Improvement of boosters in Regulation No.129

Hans Ammerlaan - Netherlands

wrt lie of belts completely different from that of the test-trolley III

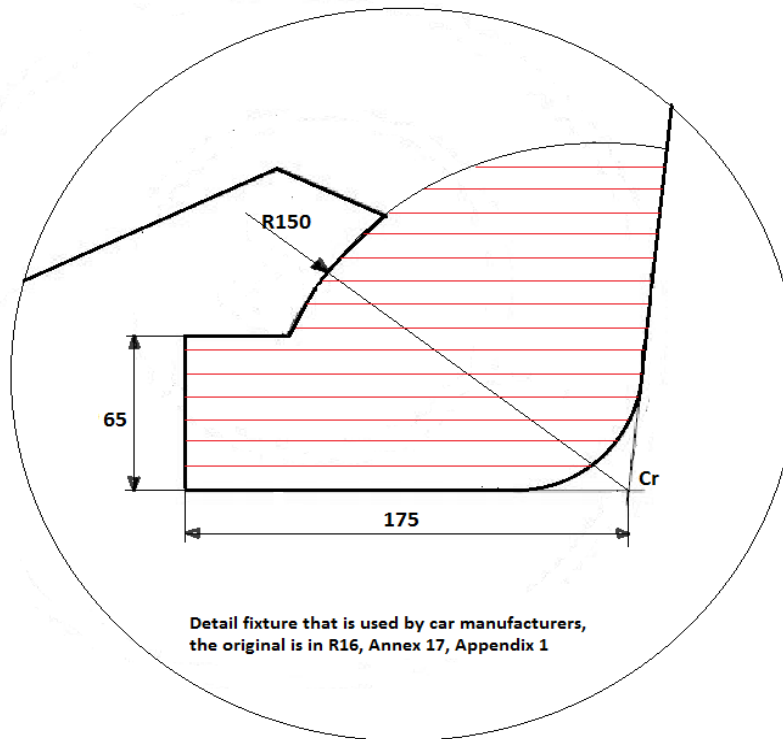
Car manufacturers utilize R16, Annex 17, Appendix I, so can use the red faded zone.

However R44 and R129 are written such that Child restraint manufacturers have to respect only the 150 mm.

So, low boosters, only fulfilling $R=150$ mm cause incompatibility, this must be improved!
